SERVICE MANUAL BULLETIN

SMB-182

ISSUE DATE: Sep 4 2018

1.1. Artic Joint Retorque & Bolt Replacement

Fig. 1: Support Frame Bolt Replacement

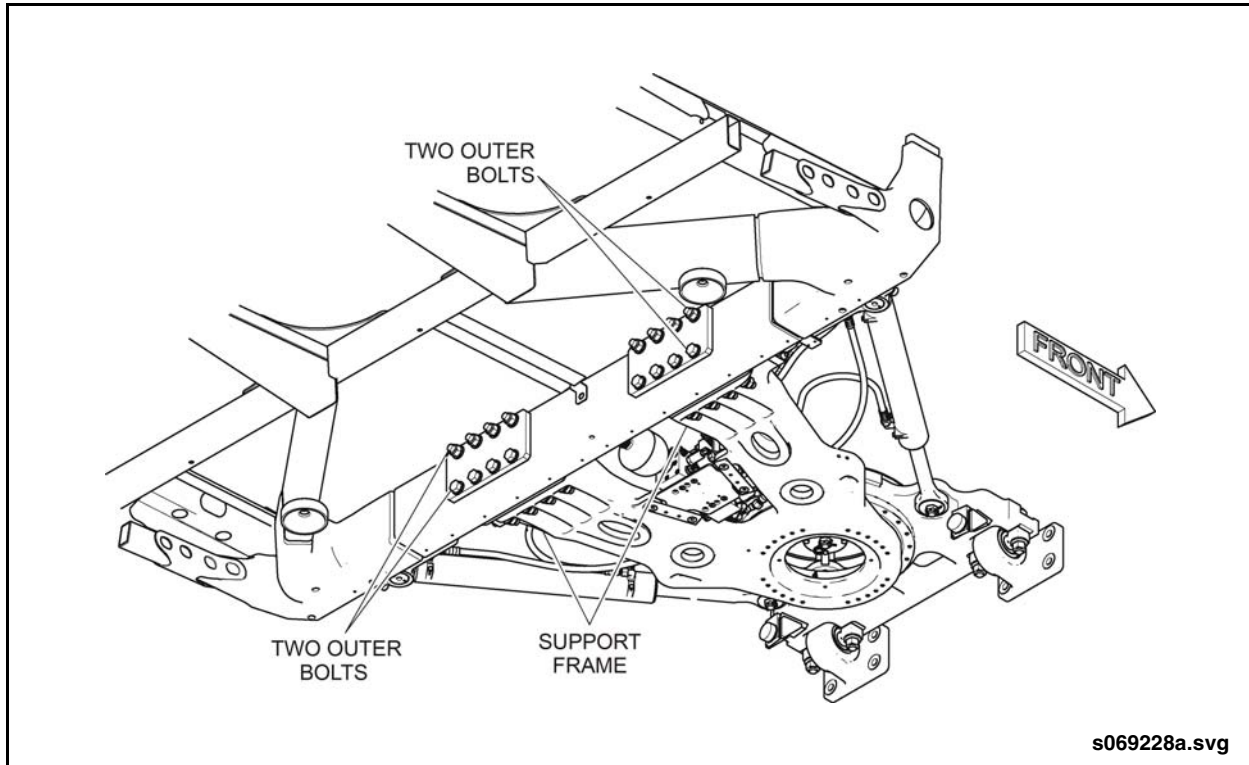
2. Replace the two outer bolts on either side of the support frame every three years or 90,000 miles (145,000 km), whichever occurs first. See “Fig. 1: Support Frame Bolt Replacement” on page 2. Refer to your New Flyer Parts Manual for correct replacement parts. Refer to Section 21 of the New Flyer Service manual for torque specifications and procedures.
